ARCHITECT'S SUPPLEMENTAL INSTRUCTIONS

Table with project details: PROJECT: The Irving Lofts, OWNER: OPG Irving Partners, LLC, CONTRACTOR: MCP Group, Report No. Three (3), Date July 1, 2026, Architect's Proj No. 24-3479, Contract For: General Construction Mechanical, Electrical

THE IRVING LOFTS
 HISTORIC RESTORATION & REHAB APARTMENTS
 CLEBURNE, TEXAS

AA2.4

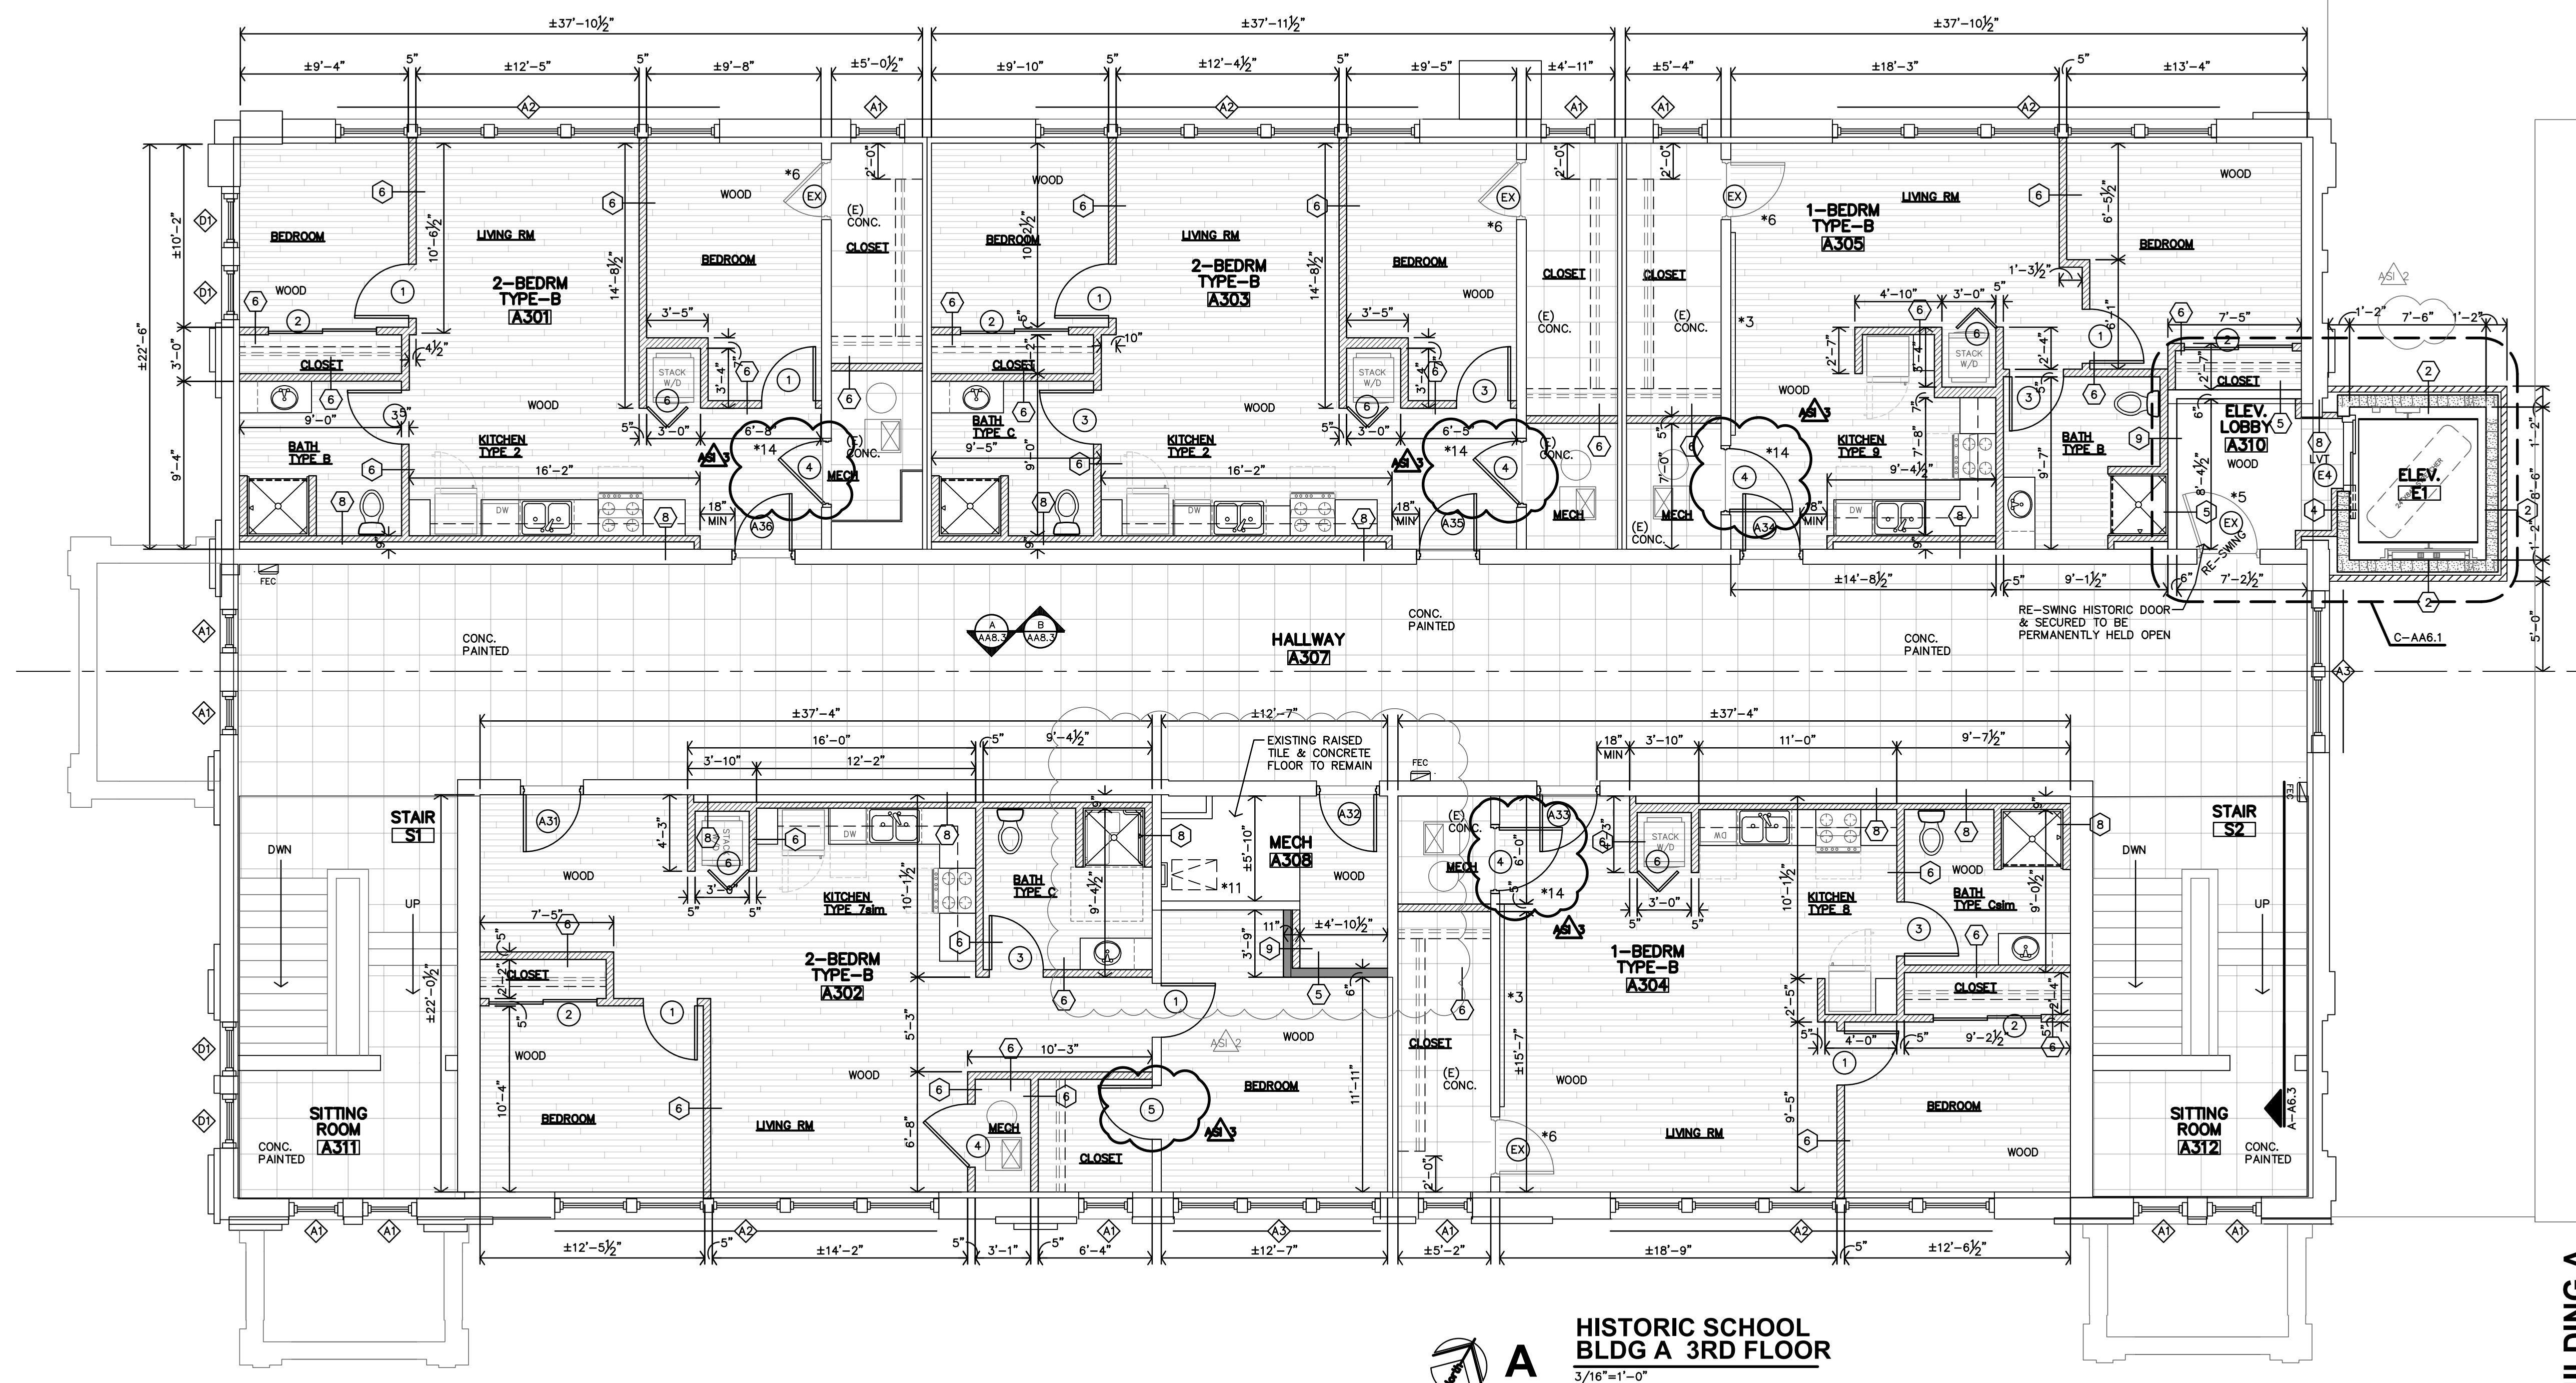
d. Sheet AA2.4
i. Historic Restoration & Rehab Notes - Specific Notes - Note 14 has been added
ii. Unit A301 - Mechanical Room door adjusted size to 3'-6" and added note 14
iii. Unit A302 - bedroom closet door revised to type '5'
iv. Unit A303 - Mechanical Room door adjusted size to 3'-6" and added note 14

v. Unit A304 - Mechanical Room door adjusted size to 3'-6" and added note 14
vi. Unit A305 - Mechanical Room door adjusted size to 3'-6" and added note 14

- ENLARGE EXISTING DOOR OPENING TO FIT NEW 42" DOOR AND FRAME FOR MECHANICAL ROOM.

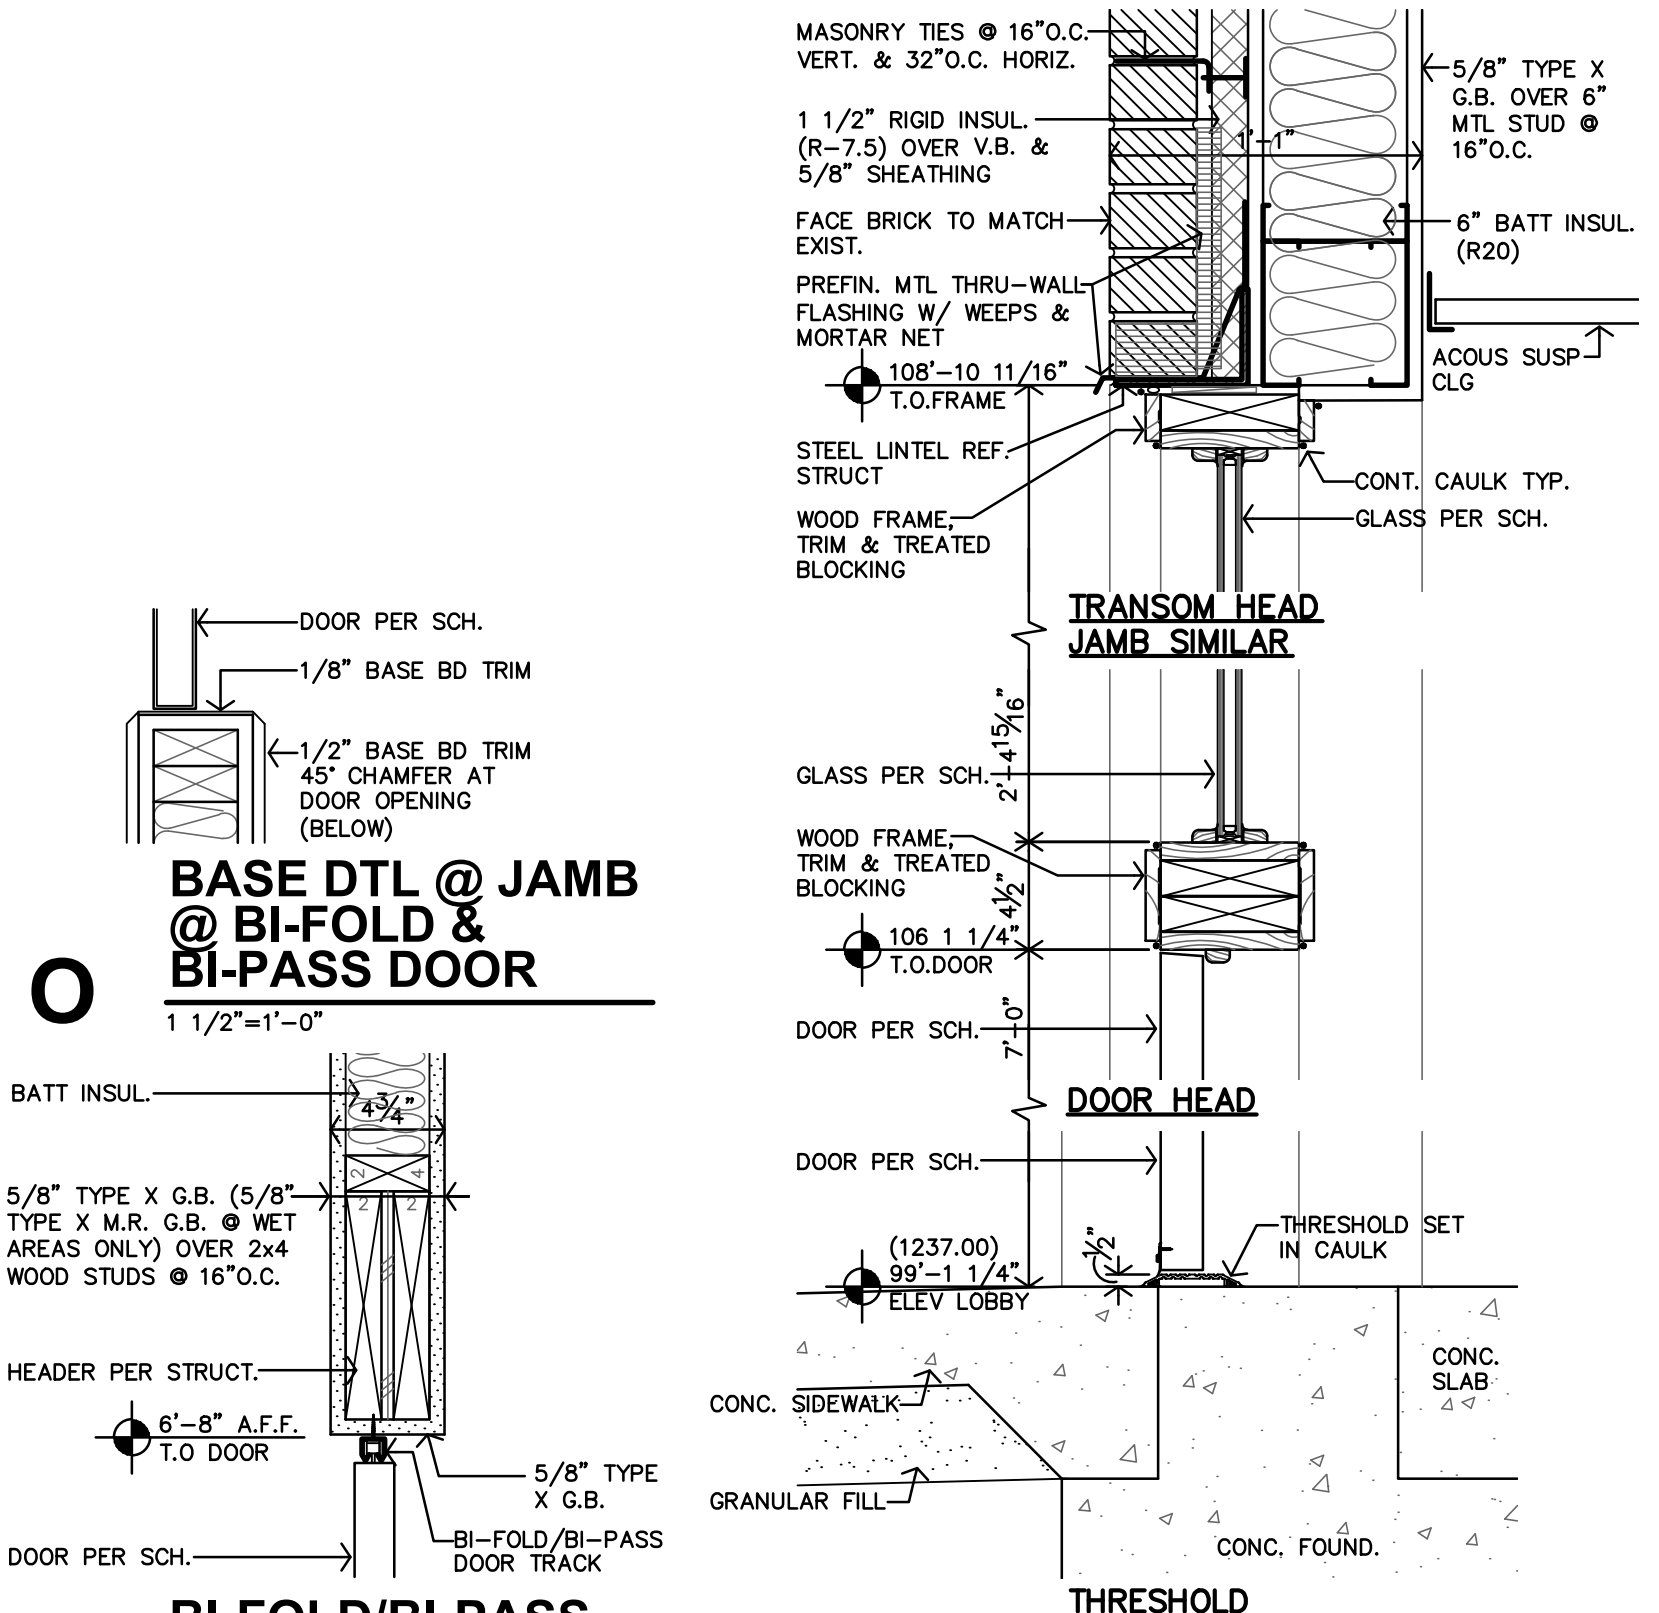
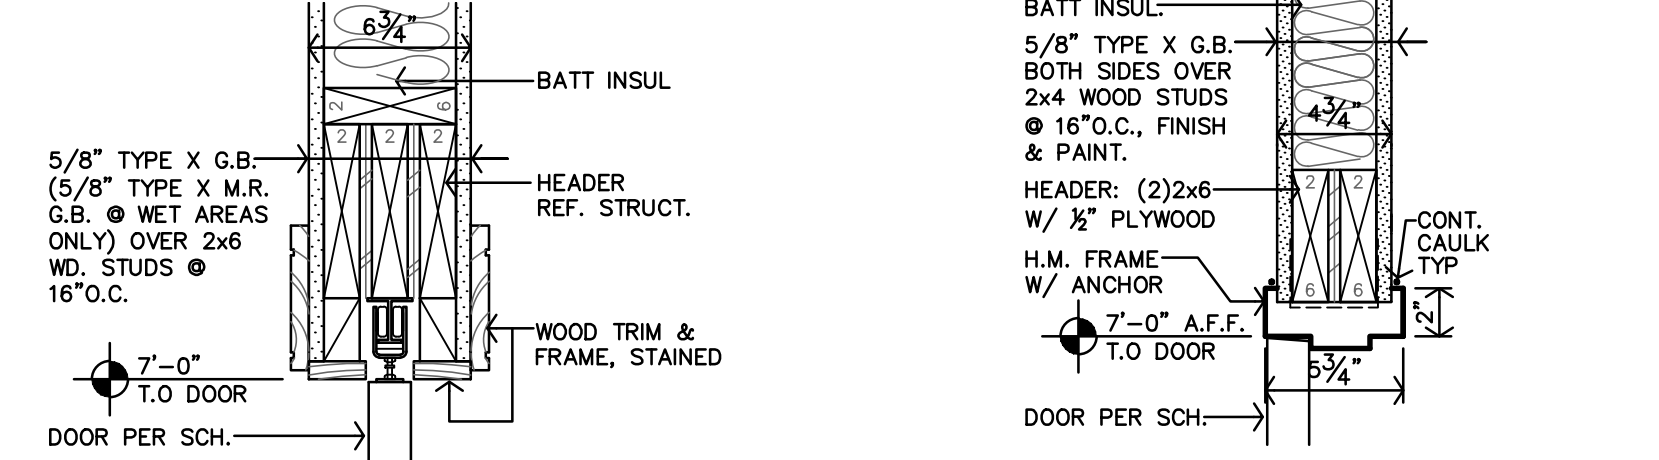
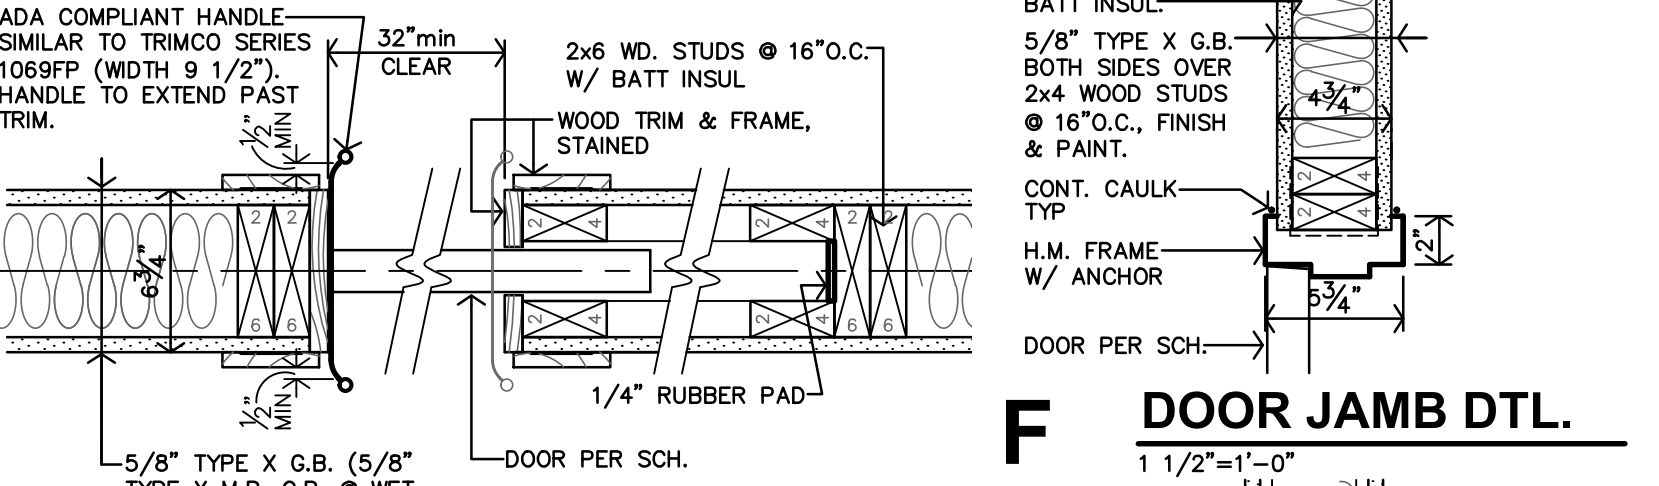
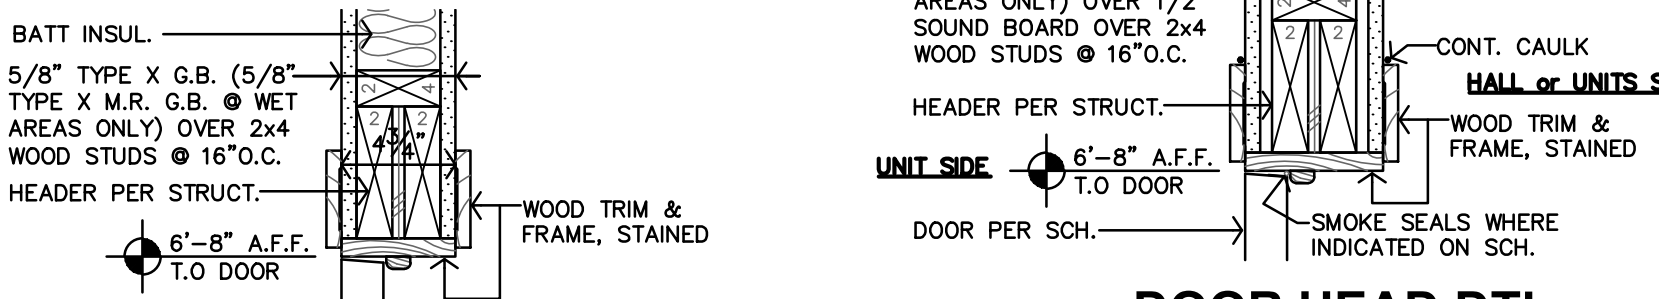
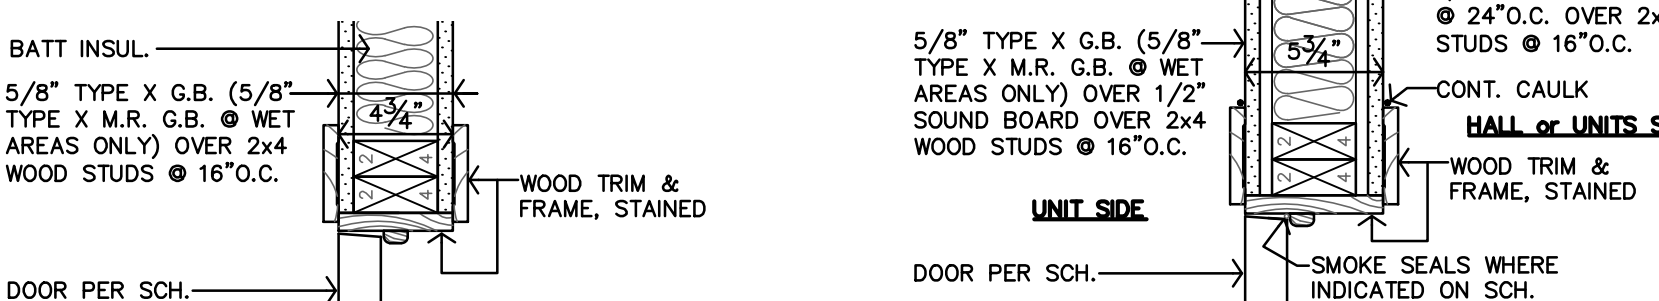
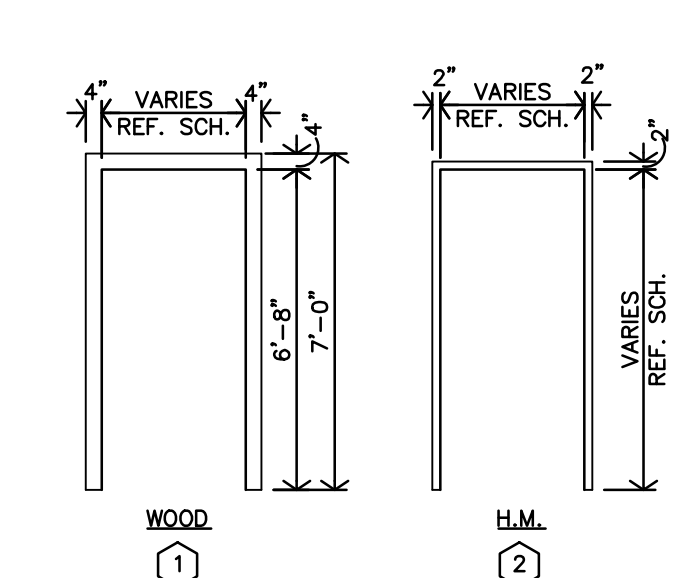
e. Sheet AA10.1
i. Doors A10 & A42 have been adjusted to 3'-6" wide
ii. Apartment Door Type 6 - Laundry has been adjusted to a 3'-0" bifold door
f. Sheet AB10.2
